Campaign Update CA#9454

Subject: A Screw may contact the Rear Leveling Jack Hydraulic Lines
Affects certain 2020 Unity Motorhomes

Battery box spacer at back.

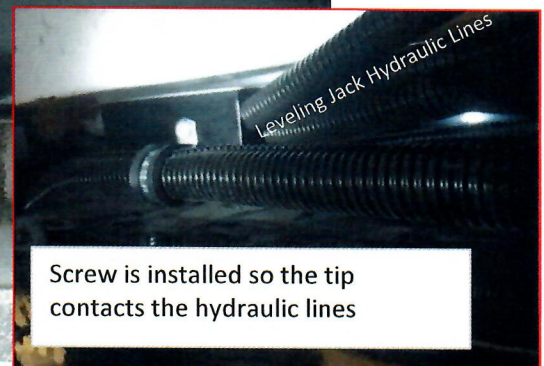
The 12V wire P-clamp is fastened through the underside of the battery box spacer which also acts as a support for the loomed leveling jack hydraulic lines.

Screw is installed so the tip contacts the hydraulic lines

To correct this situation, please follow the included photos. Please claim the labour to perform the campaign update on a warranty claim.

Repair
